## CITY PLANNING COMMISSION

- APPLICATION:
1. Variance to reduce the required 15 foot rear yard setback between commercial uses and the side yard of residential uses to three feet (Section 3-C-5)
  2. Variance to waive the required six foot high masonry wall between residential and commercial uses (Section 3-D-7-a)
  3. Lot Line Adjustment to merge four parcels into one parcel (Subdivision Map Act Section 66499.20-3/4)

LOCATION: 2360 Stockton Boulevard

PROPOSAL: The applicant is requesting the necessary entitlements to construct a 7,920± square foot office building in the General Commercial zone

# EXHIBIT D

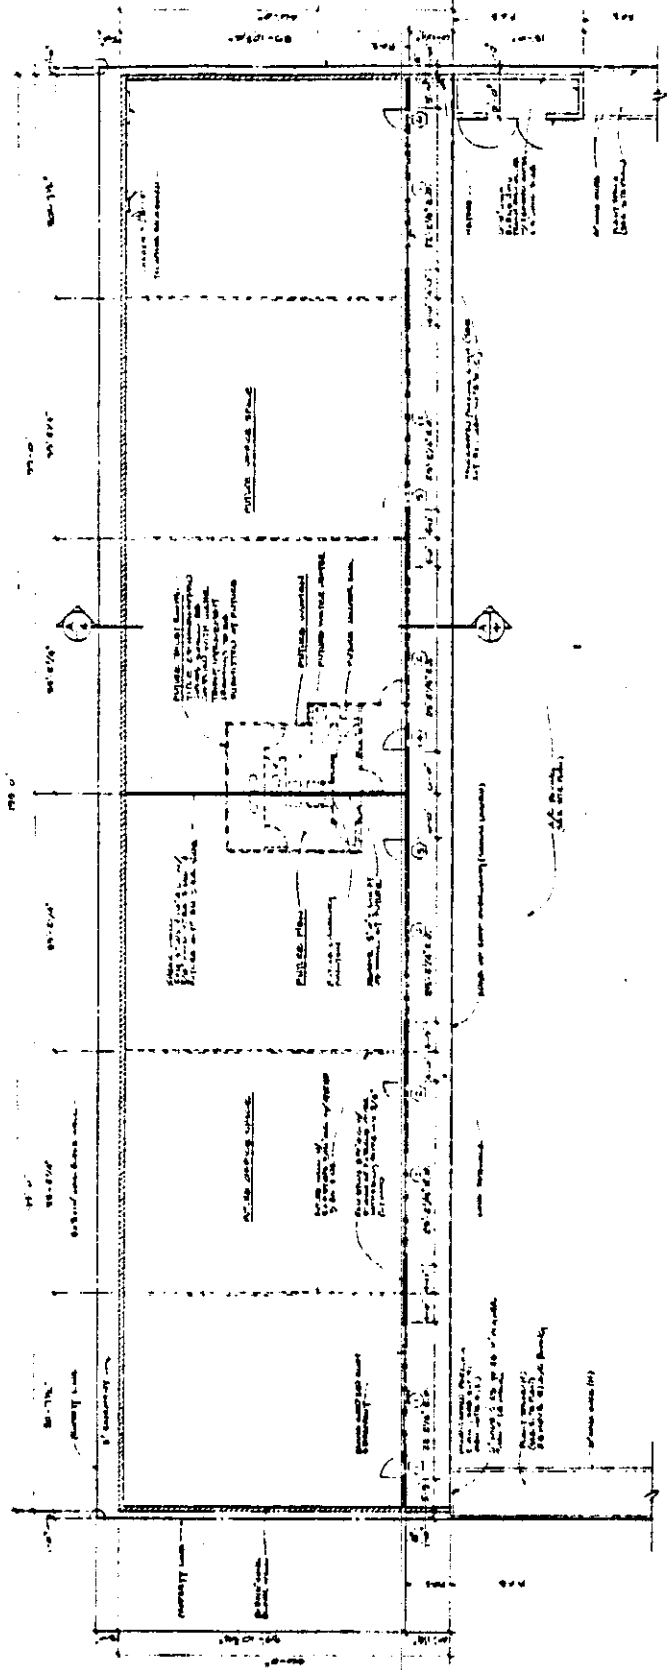
Staff, however, has concerns that the proximity of this flat solid concrete wall to the existing residential uses will have an adverse visual impact on the neighborhood. The proposed height of the building is 16 feet, making the rear and side walls of the structure clearly visible to residences adjacent to the site as well as residences on the west side of 42nd Street and the south side of Y Street (see land use map). Presently, the applicant proposes to use solid concrete block for these walls and paint the building tan and bronze. These walls should be redesigned to incorporate features that will be pleasing to the adjacent residents such as a textured surface block wall and a three dimensional wall treatment. The front facade of the building should also be redesigned to provide some movement rather than the flat facade proposed by the applicant. These changes will create a structure that is more visually compatible with the existing residential neighborhood. Staff, therefore, recommends that the applicant redesign the proposed office building to incorporate these changes. The revised design should be reviewed and approved by the City's Design Review Board prior to issuance of building permits.

## SITE PLAN

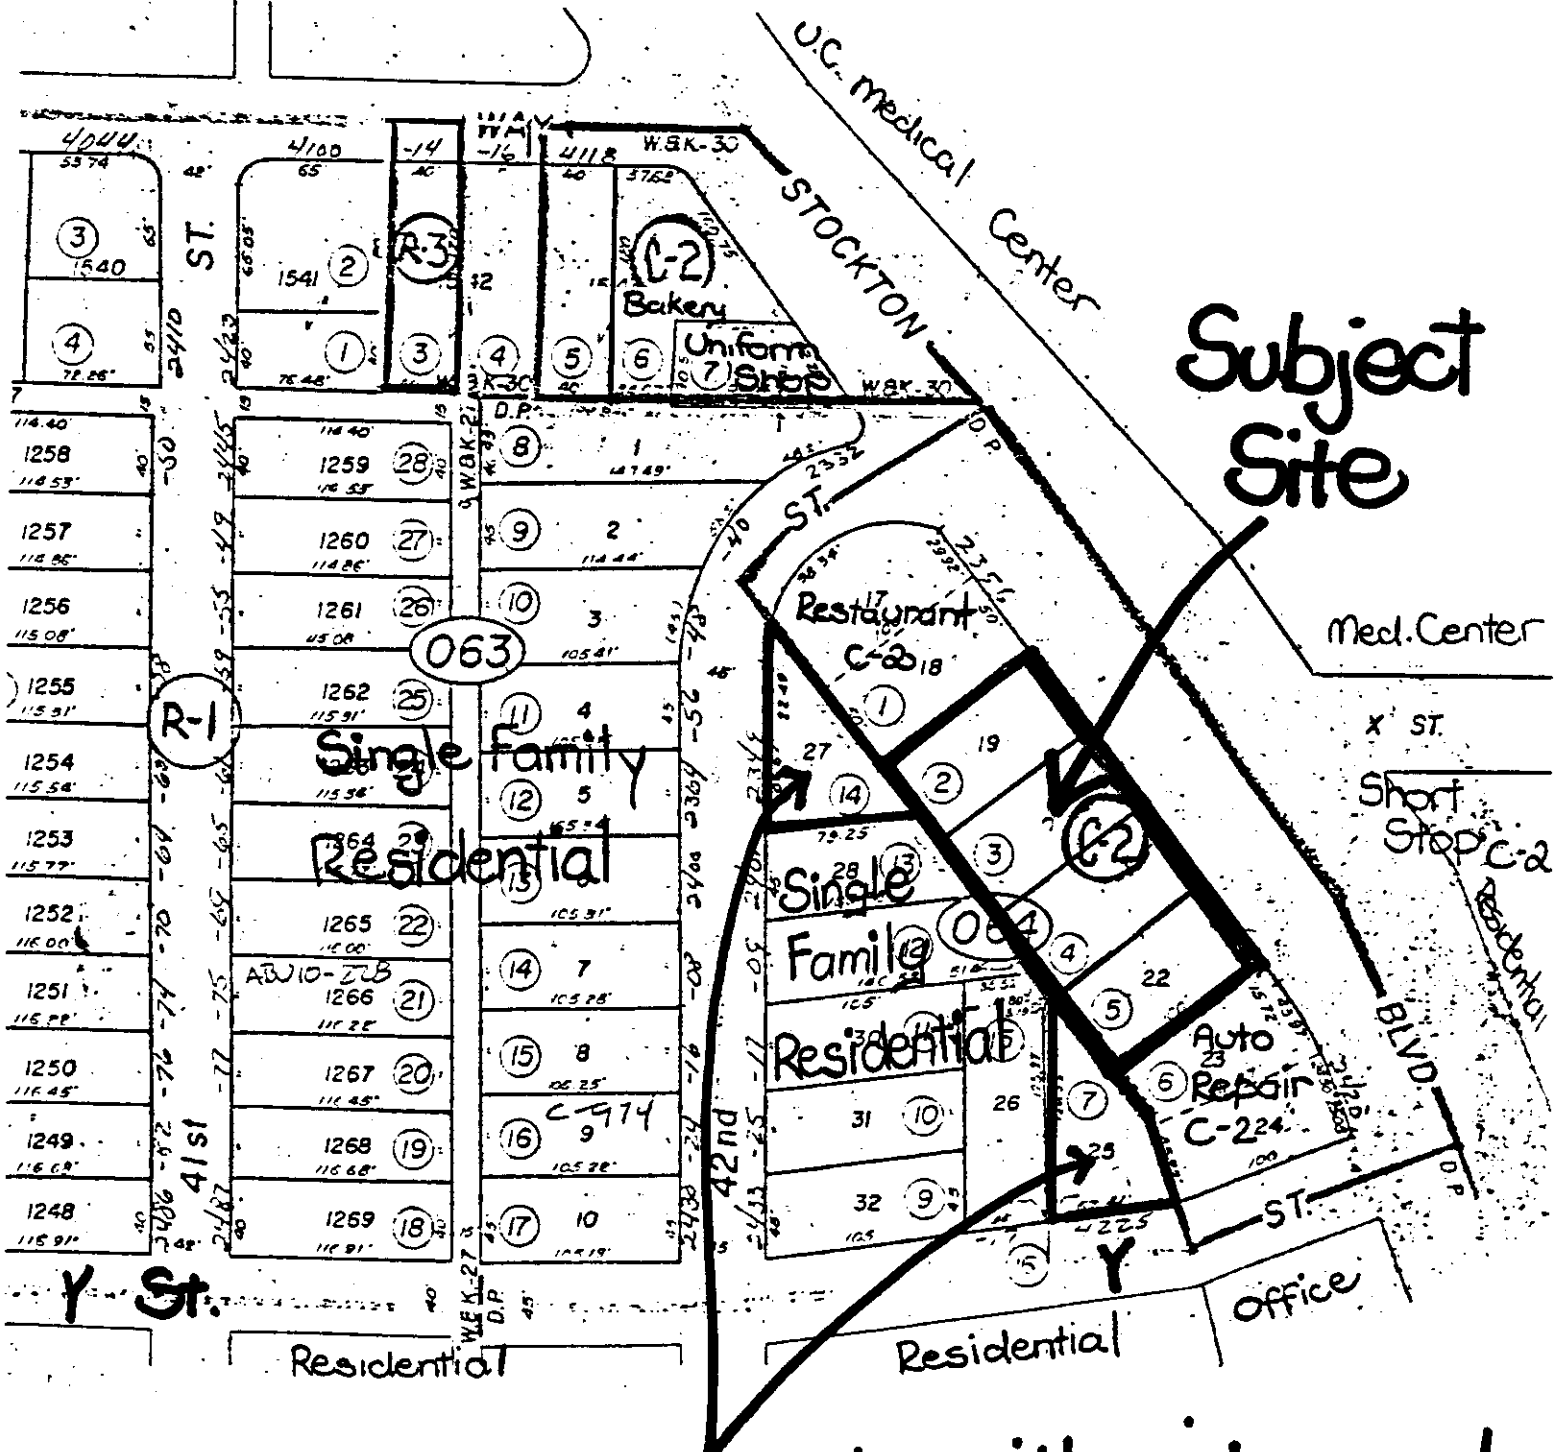
The applicant is requesting a lot line adjustment to merge the four parcels into one and build a 7,920± square foot office building on the site (Exhibits B-E). The applicant proposes to place the rear wall of the building three feet from the rear property line and is also requesting the necessary entitlements to waive the required setback and six foot high masonry wall between residential and commercial uses.

4. The Sewer and Water Division has indicated that a five foot easement, rather than the three foot easement shown on the applicant's plans, is located along the rear property line of the site. The applicant will need to revise the plans for the subject site to accommodate this easement. This may require a reduction in the square footage of the proposed office building. Staff also recommends that the applicant provide a secure gate along the north property line to limit access by unauthorized individuals to this area.

- a. The applicant shall maintain a <sup>three</sup>~~five~~ foot setback along the rear property line for the existing sewer easement.
- b. The applicant shall revise the design of the proposed office building to incorporate the design features outlined in the staff evaluation. The revised design shall be reviewed and approved by the City's Design Review Board prior to issuance of building permits.
